# UNMANNED AERIAL VEHICLES

## Medium Range System Components Do Not Fit

B-242779

March 25, 1991

Figure I.3: Medium Range UAV Normal  
Launch Sequence and Possible Hazard  
of Emergency Jettison

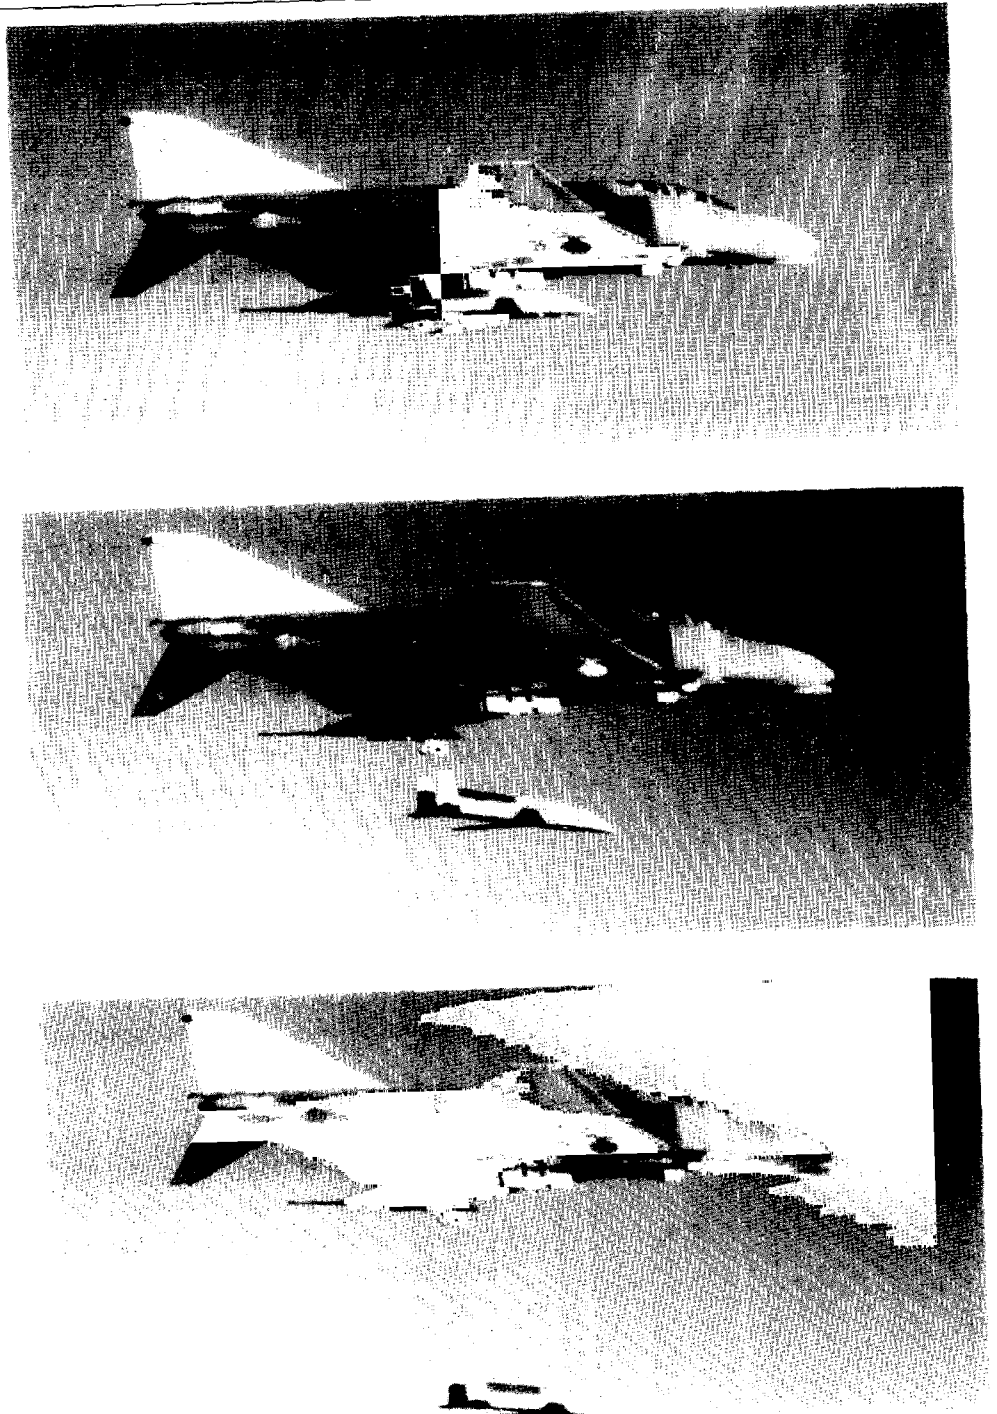
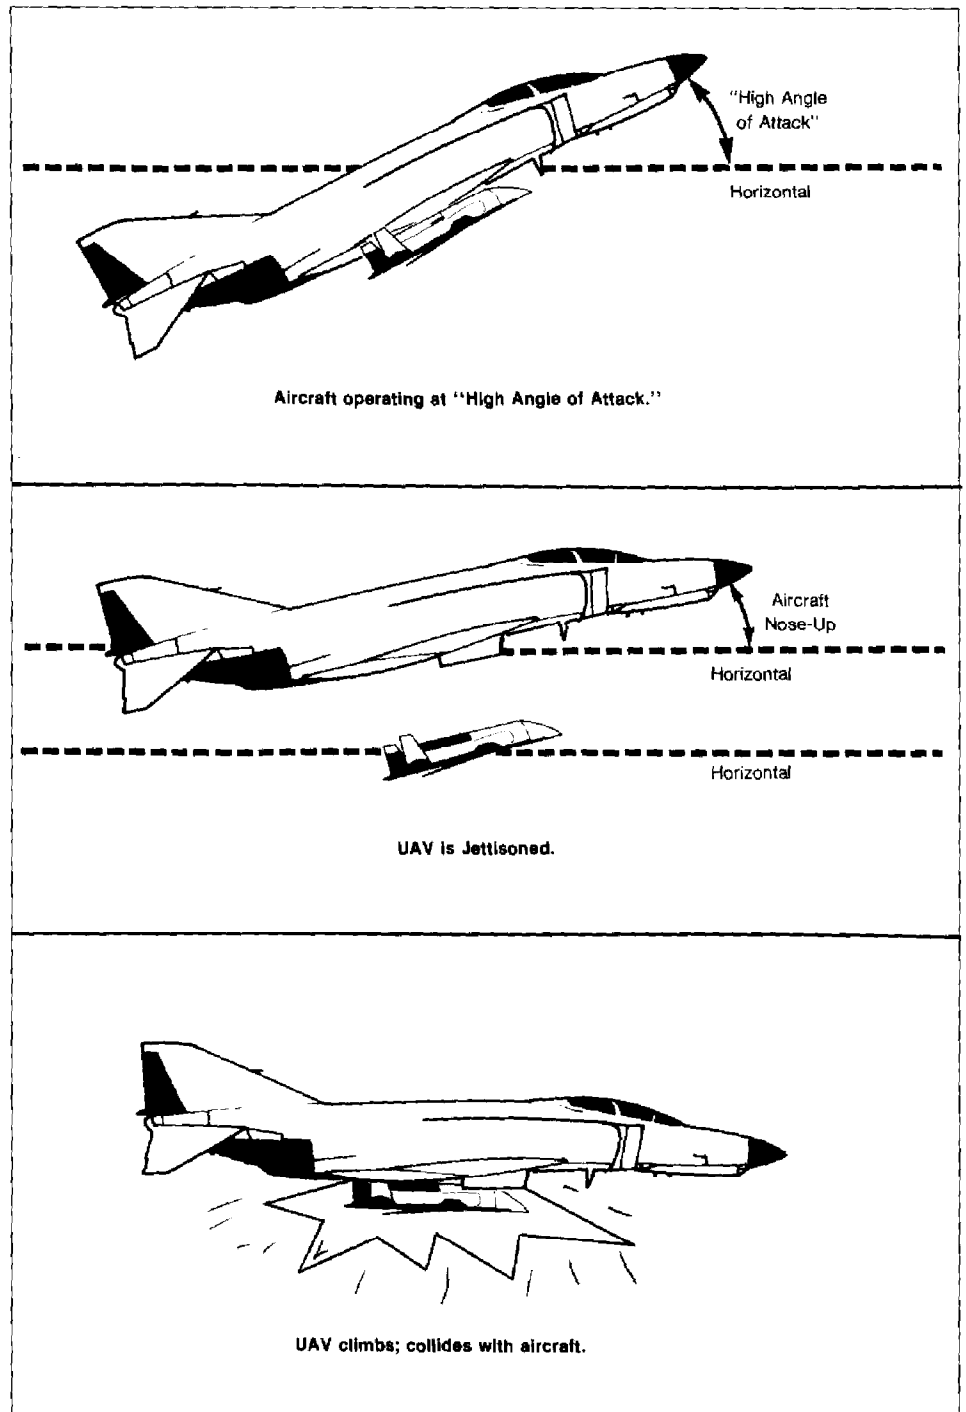
Assuming that the UAV does not come apart while being carried by the F/A-18, according to DOD officials, it would still be considered unsafe for carrying on the aircraft. According to Medium-Range UAV program officials, the UAV's design could cause it to lift and crash into its launching F/A-18 during an emergency UAV jettison if the aircraft's nose is up at the time, such as directly after catapult launch from an aircraft carrier. (See fig. I.3.)

In this case the UAV may not fall down and away from the aircraft when released but may actually climb and strike the launch aircraft's wings or fuselage. Wind tunnel tests are scheduled for February 1991 to confirm or disprove that this is a problem.

- **Design Could Cause Crashes of Manned Aircraft.** While design could be a problem, no conclusive data exists at this time. Wind tunnel tests scheduled for February 1991 should either confirm or reject whether it is a problem--and if so, to what extent.
